RAMP RETAINING WALL
INTERSTATE ROUTE H-1
SAFETY IMPROVEMENTS AT
THE PUNAHOU STREET OFF-RAMP
F.A.I. Proj. No. IR-HI-1(160)

STATE OF HAWAII
DEPARTMENT OF TRANSPORTATION
LAND TRANSPORTATION FACILITIES DIVISION
TYPICAL WALL SECTIONS
INTERSTATE ROUTE H-1
SAFETY IMPROVEMENTS AT
THE PUNAHOU STREET OFF-RAMP
F.A.I. Proj. No. IR-H1-1(160)

ENCLOSURE FOR A.C. COOLING TOWER
RAMP RETAINING WALL
INTERSTATE ROUTE HI-1
SAFETY IMPROVEMENTS AT
THE PUNAHOU STREET OFF-RAMP
F.A.I. Proj. No. IR-HI-1(160)
Scale: As shown Date: Nov. 1982
SHEET NO. 40 OF 4 SHEETS

JOINT ELEVATION

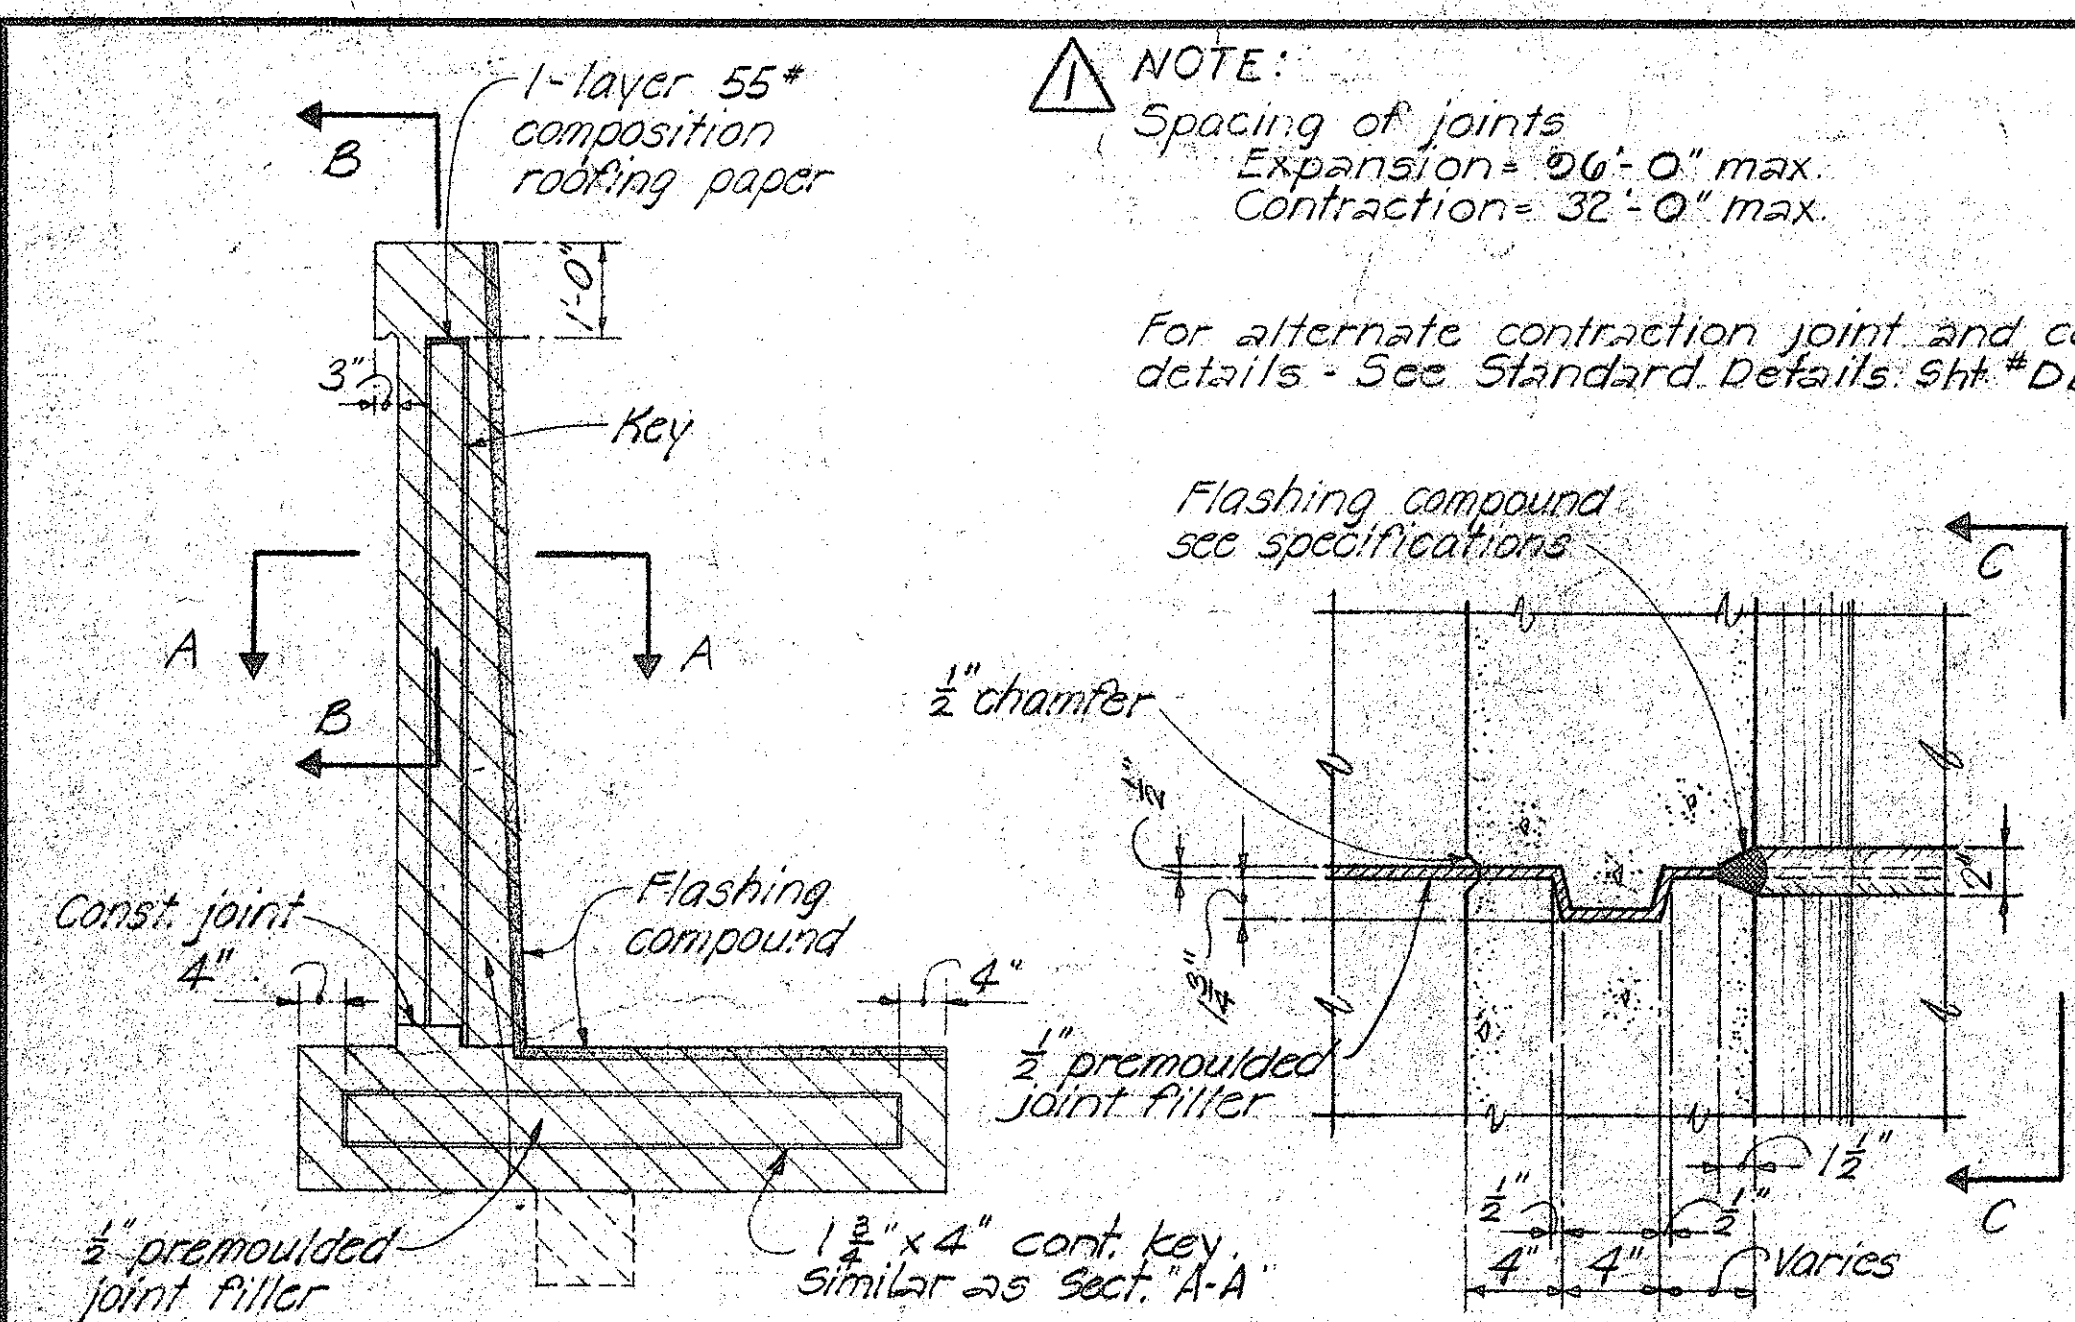
NO.	REVISION	APPROVED BY	DATE
1	Change note spacing of joints.	H.T.	2.4.72

NOTE:
Spacing of joints
Expansion = 36'-0" max.
Contraction = 32'-0" max.
